LA13-1
cont'd

A. Overview of Montgomery County, Virginia's Interest in Proceeding

Montgomery County, Virginia, an intervenor in this proceeding, is located in southwestern Virginia, with a population of approximately 98,000 residents. The pipeline as proposed would run through nineteen miles of the northeast section of the County, utilizing a 125-foot easement for construction and a permanent 50-foot easement for operation of the pipeline (DEIS 2-24).⁵

Figure 9. Map Showing Location of Greater Newport Rural Historic District (035-0412)

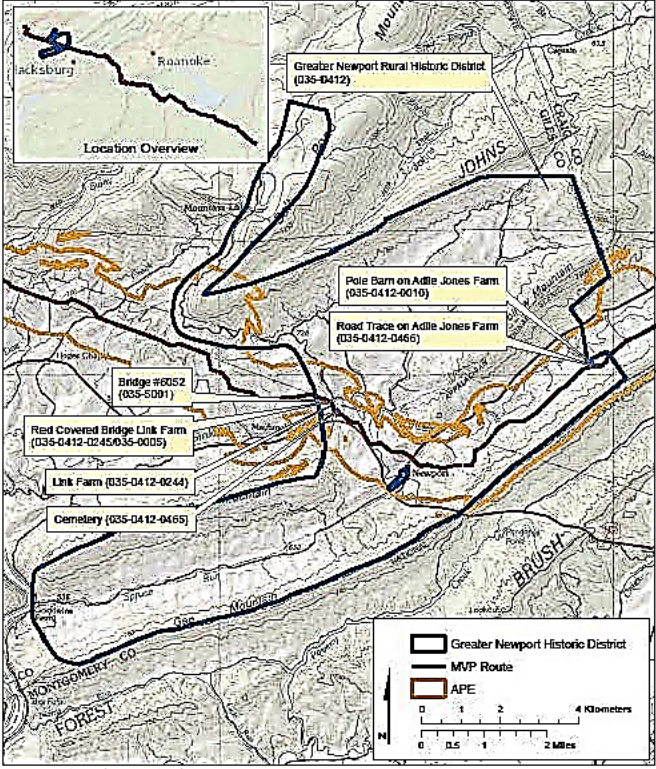
4. The APE maps provided in Resource Report 4 Appendix 4S Draft APE are for the APE-Newport Variation, not the preferred corridor. The Application contains no APE maps for the proposed pipeline in the District. Due to this deficiency, it is impossible for the Committee to comment conclusively on an APE for the preferred corridor that is not even presented in the Application. However, in the absence of Company maps in the Application showing the impacts of the preferred corridor on the District, the Committee provides a map (Figure 1) showing the general locations of the two pipeline corridors in relation to the Greater Newport Rural Historic District and Newport Historic District.

Figure 9. Preliminary Boundary for Proposed Bent Mountain Historic District

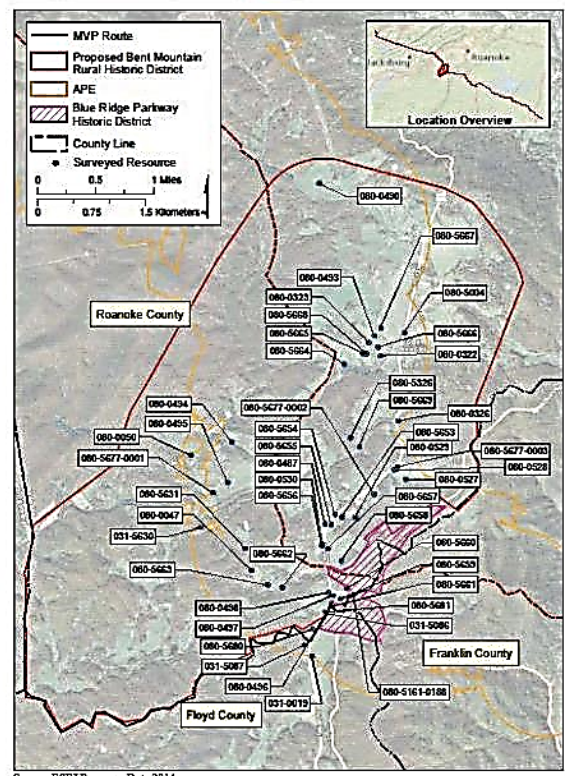
CO9-9
 cont'd
